10 March 2025 (Endorsed by Council)

CITY OF PARRAMATTA COUNCIL SUBMISSION ON THE PARRAMATTA NORTH REZONING PROPOSAL

Figure 2 – Recommended indicative high density urban edge (pink blocks) framing the central heritage setting

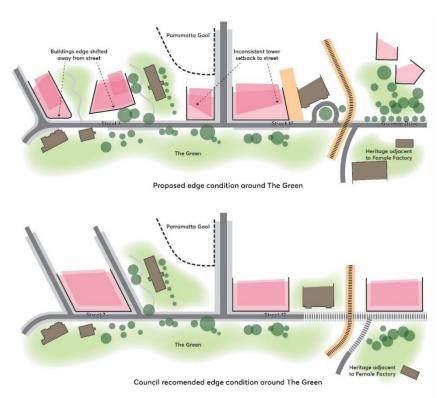
To reinforce the significance of the central green heritage parkland core, the Structure Plan should create a defined, high-density urban edge that separates small-scale heritage buildings. This should be supported by a distinctly different rectilinear and connected urban spatial structure of streets and blocks, that integrate with the existing road pattern beyond the site both physically and visually. This ensures that the new urban development blocks are an extension of the broader urban fabric (**Figures 2** & **3**).

The proposed layout of the new higher density zones should consist of smaller development blocks, with all buildings having street frontages, backs of buildings facing backs, and fronts facing fronts across a hierarchy of well-proportioned local and main streets. Ambiguous and irregular private open spaces that create awkward built forms should be replaced with formal streets and regular block shapes, establishing a clear hierarchy of public and private spaces and reinforcing the spatial hierarchy of streets (**Figures 2** & **3**).

- 2. A high-density urban edge framing the central heritage setting Configure high-density development around the central heritage setting to provide a distinctive urban edge.

Figure 4 – Diagram (left) showing current variations of proposed street wall and upper-level setbacks along Hawkesbury Rd that do not reflect spatial structure, building typologies and land use. Indicative diagram (right) showing Council-recommended single setback condition.

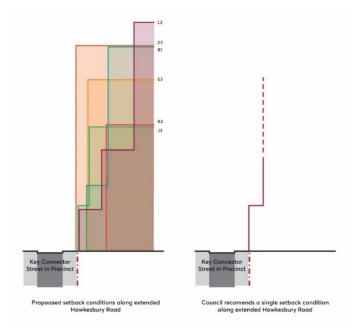
Council is concerned for the current variations of street wall and upper-level setbacks proposed that do not reflect spatial structure, building typologies and land use (refer to **Figure 4**). Each street should be designed individually with a consistent built form. Buildings along street edges should be considered as part of a cohesive and well-proportioned composition. Where relevant, street elevations should face each other across the street, ensuring well-proportioned street width and building height. Key streets, including Fleet Street, New Street, O'Connell Street, and Hainsworth Street, should be analysed and designed with consideration for the quality and experience of existing streets affected by the development.
